To,
The Commissioner, Planning
Master Planning Department,
Vikas Sadan, DDA
New Delhi.

SUB : OUR OBJECTIONS/SUGGESTIONS OF THE ZONAL PLAN OF ZONE J

ROAD - A

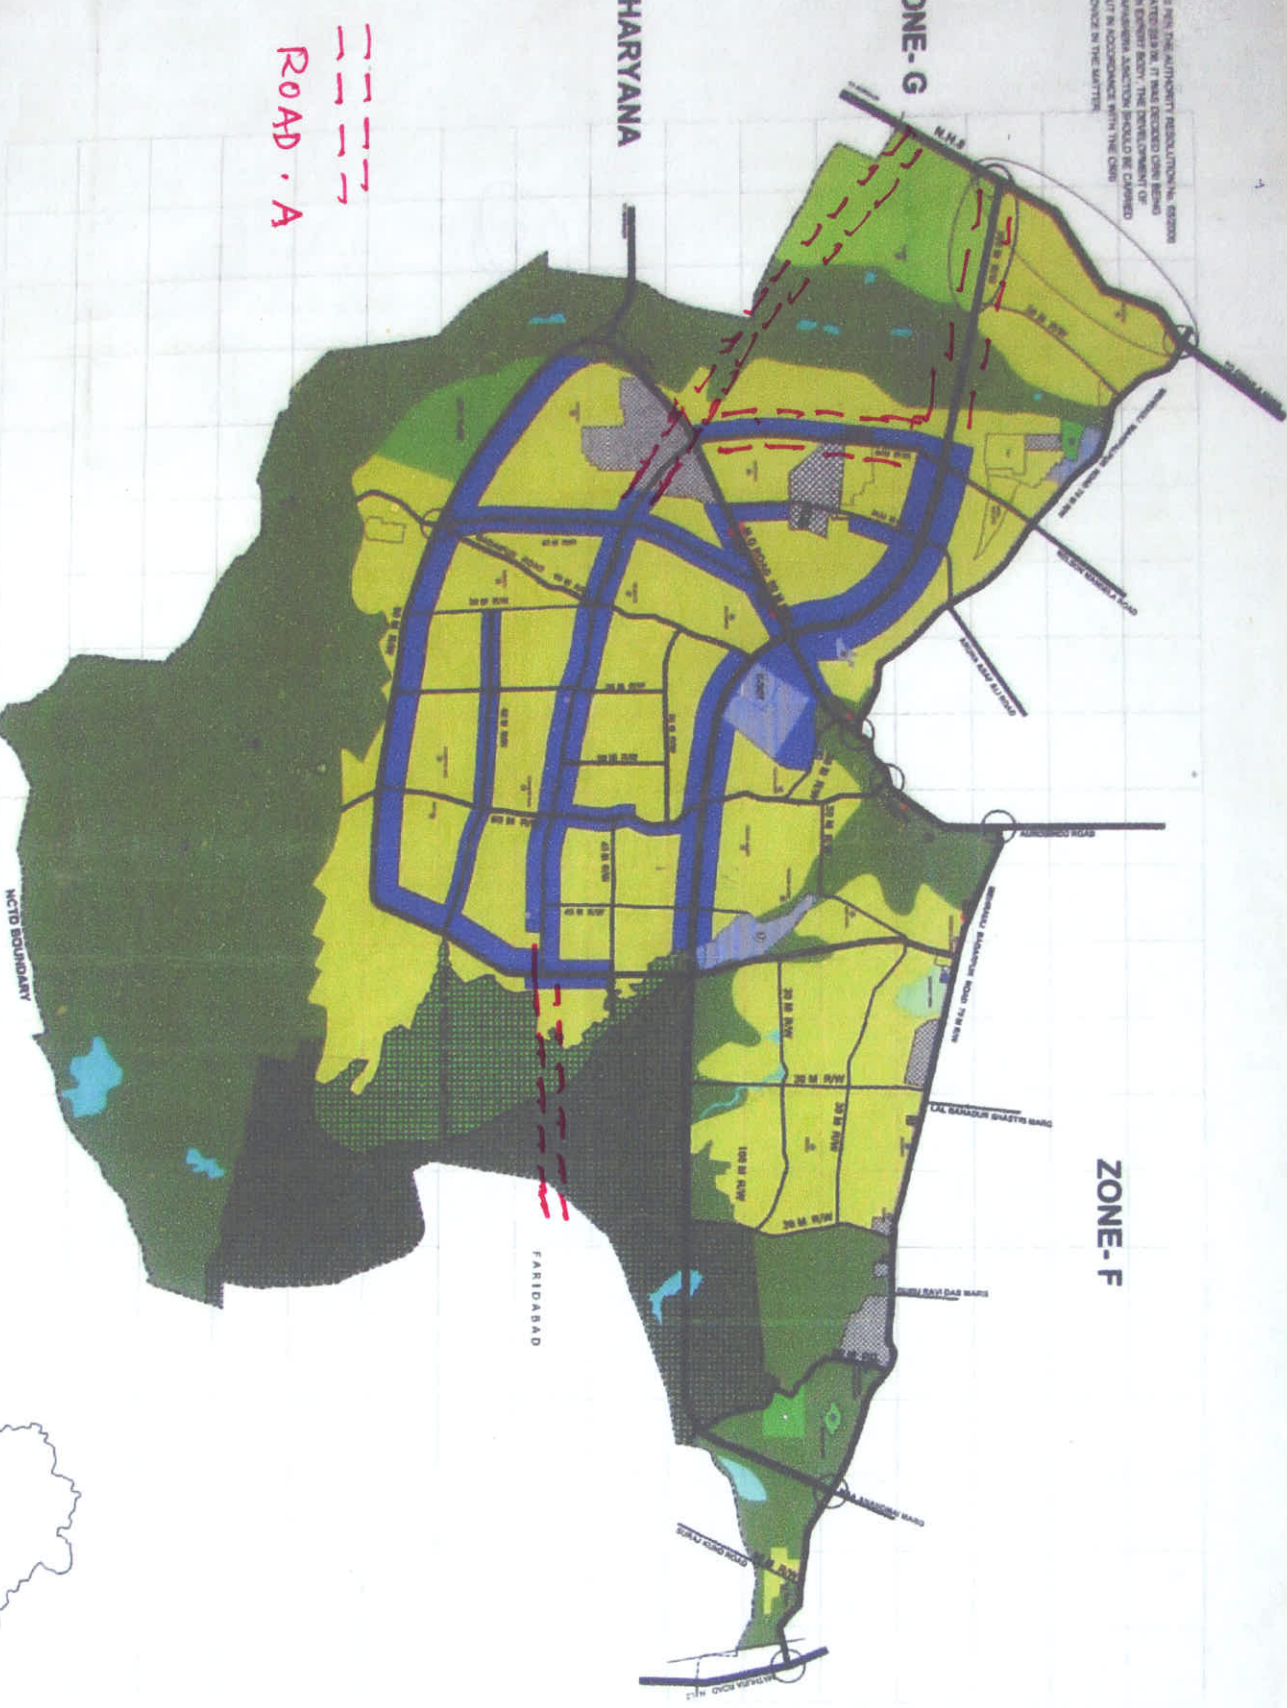
In the plan envisaged, there is a suggestion of a 100 meter road to be newly made. Unfortunately it passes through a very large numbers of existing, developed settlements. It would be unfortunate if all existing residential & settlement areas be disturbed in this manner.

If needed, it can be replaced by the road as marked in the enclosed plan (A). Actually 60% of this road already exists and since most of it passes through Govt. land & parks, it will be no problem to acquire and will not disturb any existing residential areas, abadis or institutions.
